ADDENDUM DATE: December 14, 2023

ADDENDUM NO. 4

Cobblestone Manor
1050 Lamplighter Drive
Grove City, Ohio 43123

Addendum No. 4 to the Drawings and Project Manual, dated June 8, 2023, Cobblestone Manor as prepared by Moody Nolan, Inc., 300 Spruce St. Suite 300, Columbus, OH 43215.

#	DATE	CHANGE DESCRIPTION
3	12/15/23	Addendum 4

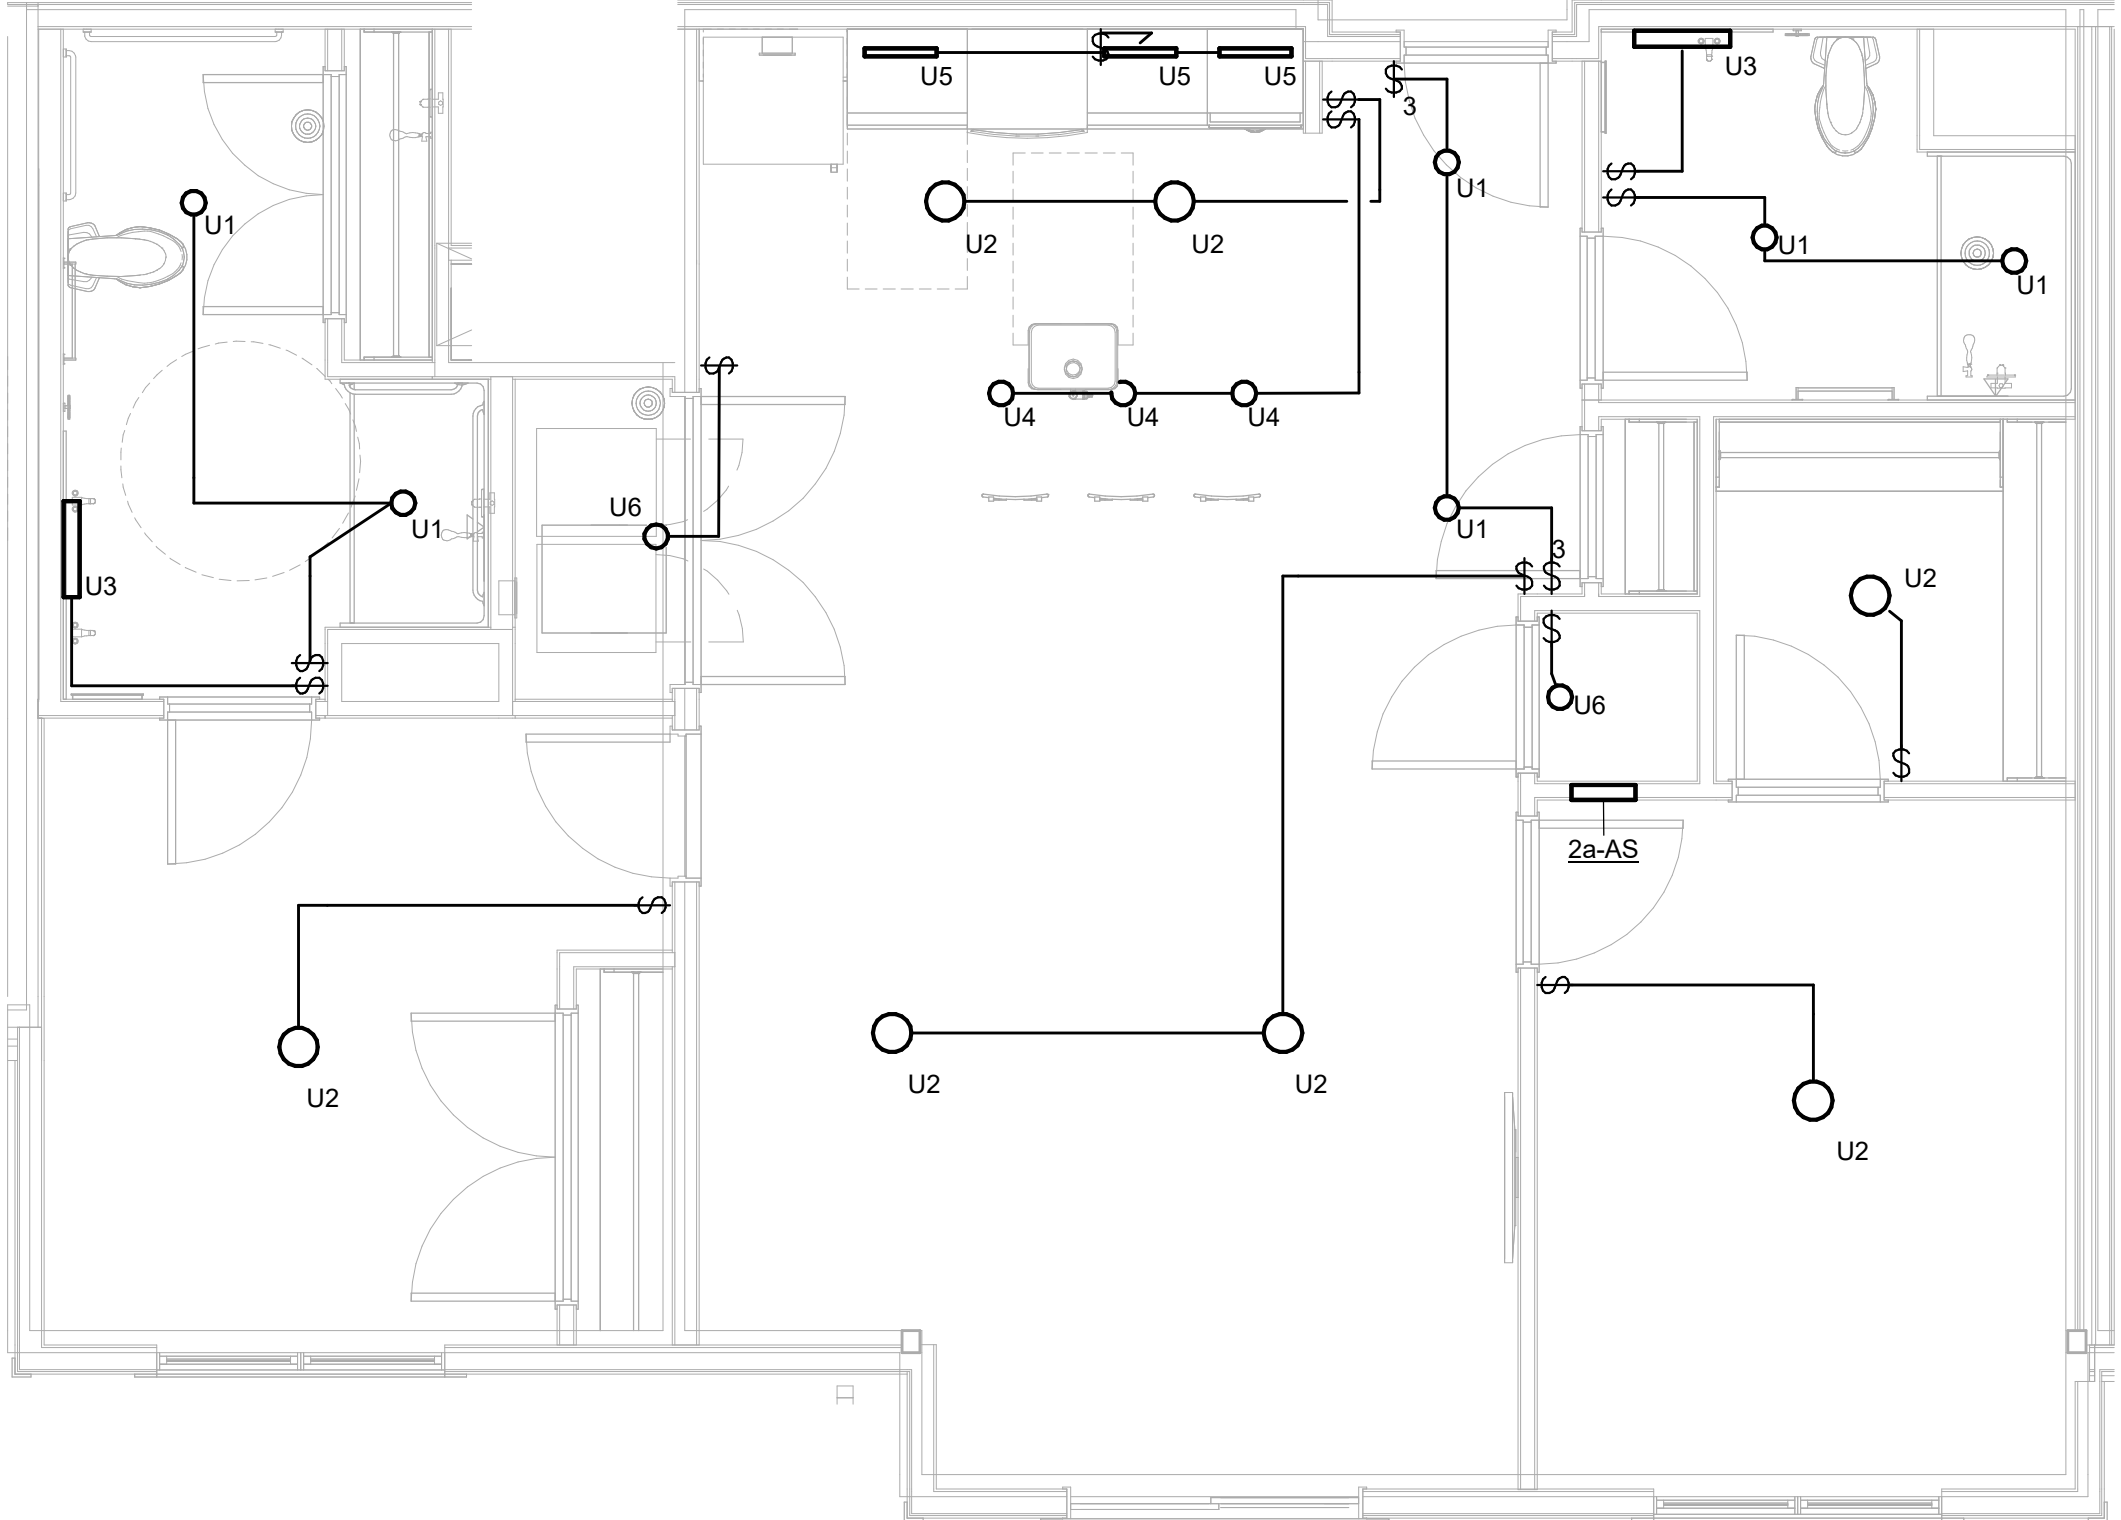
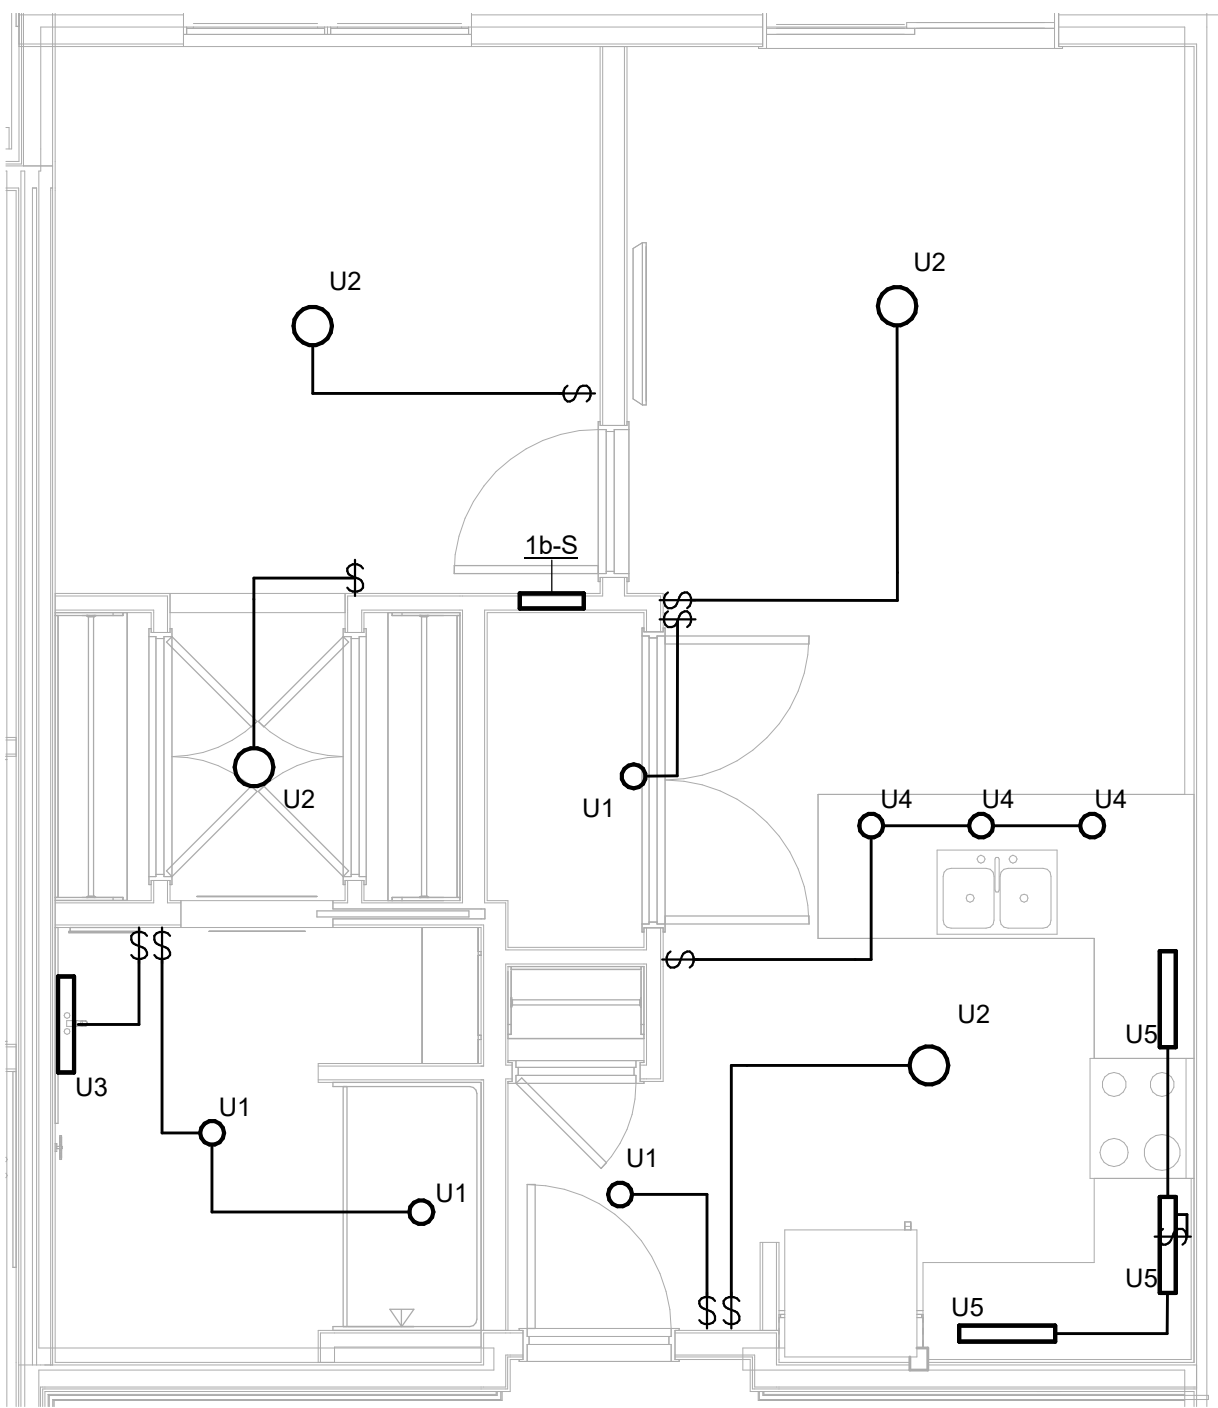
f. E403 – ENLARGED PLANS – ELECTRICAL TYPE AS

1. **DELETE** general notes M and O.
2. **ADD** low frequency fire alarm devices to unit bathrooms.
3. **ADD** RG6 and CAT6 cables from each residential unit structured media cabinet back to local demark, keynote 7.
4. **REVISE** General Note P to read as follows:
 - a. RESIDENTIAL UNIT SMOKE DETECTORS SHALL BE SYSTEM TYPE AND SHALL BE INTERCONNECTED IN SUCH A MANNER THAT

1 ENLARGED PLAN UNIT CEILING PLAN - 1b-S - LIGHTING
1/4" = 1'-0"

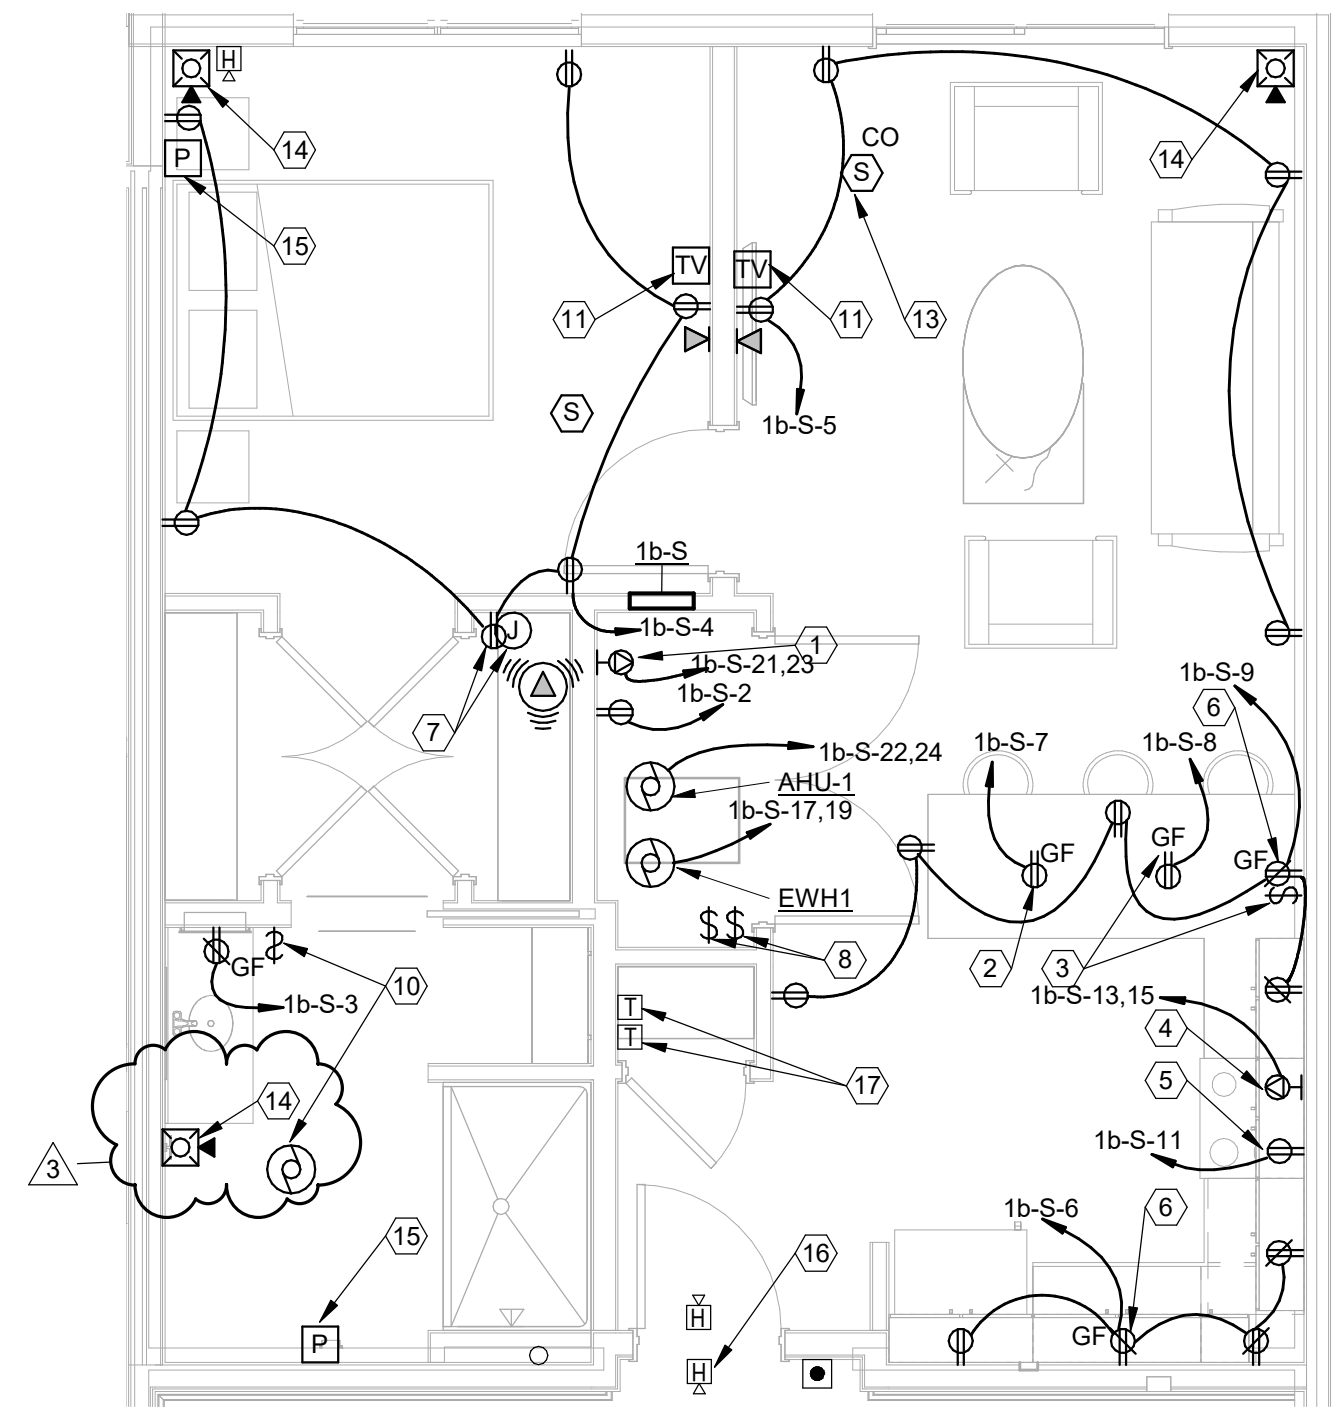
- g. E404 – ENLARGED PLANS – ELECTRICAL TYPE S
 - 1. **DELETE** general notes M and O.
 - 2. **ADD** low frequency fire alarm devices to unit bathrooms.
 - 3. **ADD** RG6 and CAT6 cables from each residential unit structured media cabinet back to local demark, keynote 7.
 - 4. **REVISE** General Note P to read as follows:
 - a. RESIDENTIAL UNIT SMOKE DETECTORS SHALL BE SYSTEM TYPE AND SHALL BE INTERCONNECTED IN SUCH A MANNER THAT ACTIVATION OF ONE DETECTOR WILL ACTIVATE AUDIBLE/VISUAL ALARMS WITHIN THE INDIVIDUAL UNIT.
- h. T101A – LEVEL 01 – FLOOR PLAN – AREA A
 - 1. **CLARIFY** scope of work for front entry intercom station.
 - 2. **ADD** guard station intercom at Admin A100.
